Access Compliance Report

Public Rights-of-Way

(Curb Ramps)

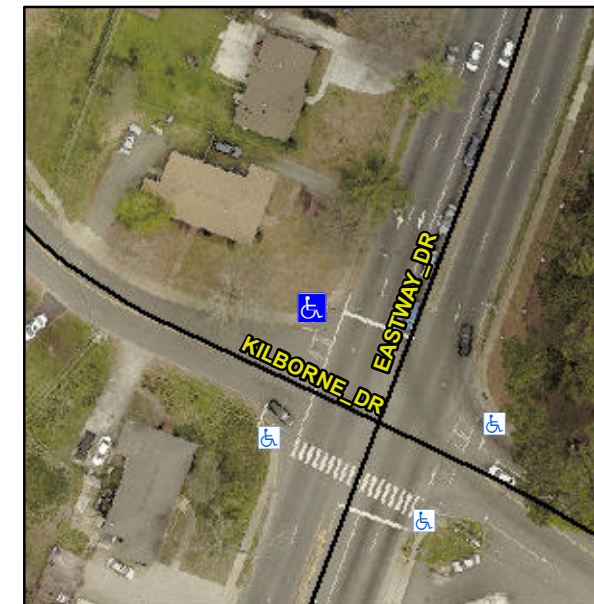
Intersection ID: 12293	Main Street: EASTWAY_DR	Cross Street: KILBORNE_DR	Location:	N
ADA ID: A6CED2BB24E0	Ramp Type: PerpDiag	Initial Pass/Fail: Fail	Overall Compliance: No	Severity Score: 37.5
Codes/Mitigation Info/Possible Solution		Field Measurements/Component Compliance

Not Found, R304.2.2, R304.5.3

Remove & Replace Curb Ramp With Two New Directional Ramps or Equivalent. Restripe Crosswalk.
